HISTORIC LANDMARK COMMISSION

RONALD McDonald HOUSE
PLNHLC2011-00503
901 East South Temple
February 2, 2011

The Ronald McDonald House, represented by CRSA Architects, is requesting approval of a Certificate of Appropriateness Involving New Construction of a building with a fifteen (15) foot height exception.

Attachment A
Proposed Elevations

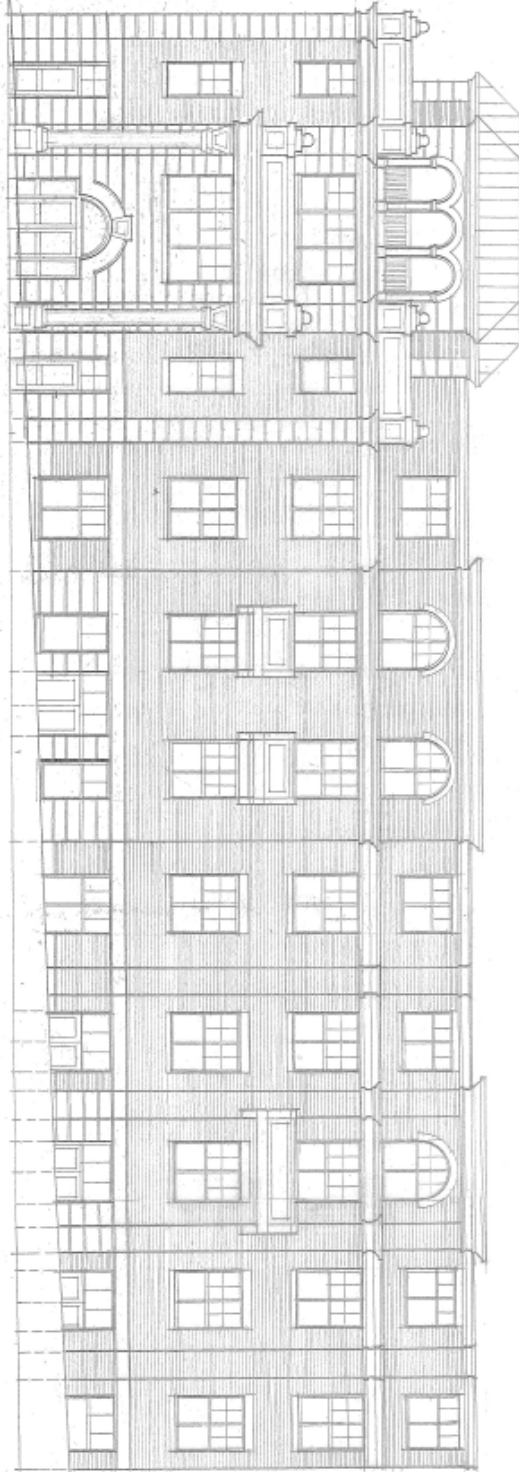
Analysis: The applicant has revised design C to have a more significant entry facing South Temple, reflecting the direction given by the HLC, and is requesting final review and approval. In reviewing the proposal, staff has found that the revisions to the building are an improvement, in that the design changes combine to make the building more architecturally compatible with other buildings along South Temple. The new features of the building are similar to those found on other large, significant buildings along the street. Changes to the design add emphasis to the south west corner of the building creating a significant entry with large columns supporting a second story balcony. With the exception of the corner chapel element, the structure is proposed with flat roofs, with a significant cornice along the top. Increasing the size and weight of the top cornice and the inclusion of lintels over the windows will create a visual effect of capping the height of the building.

The Commission has consistently emphasized the need for a significant entrance to the building, in this way, the building would “acknowledge” the South Temple frontage. The applicant responded by adding a porch and a different, more visible, entry to the southwest corner. Staff has reviewed the entrance, and finds that the current design features a significantly more substantial entry element that goes a long way toward creating a nexus between the building and South Temple, which, when combined with the other features of the structure, constitute a significant upgrade in the design over the previous version.

Analysis: The Commission has emphasized the need to have a prominent entry to the building along the front façade (facing South Temple). The applicant responded by bolstering up the front entry on the southwest corner with an arched doorway, and a second story balcony supported by two large columns. This porch has the effect of orienting the building toward the street, and cementing its relationship with the sidewalk. Staff analysis indicates that the entry is significant and creates a nexus between the building and South Temple, which, when combined with the other changes to the structure, constitute a significant upgrade in the design over previous versions.

Another change that significantly upgraded the building design is the inclusion of heavy lintels above each of the windows, and the requirement that they be recessed from the front façade by at least 4 inches. This enhancement bolsters the rhythm of solids to voids along each of the facades as it makes the building more visually interesting and compatible with similar architecture in the surrounding area.

7. In order to create visual interest and façade variation, the windows shall be recessed from the front wall by at least 4 inches.
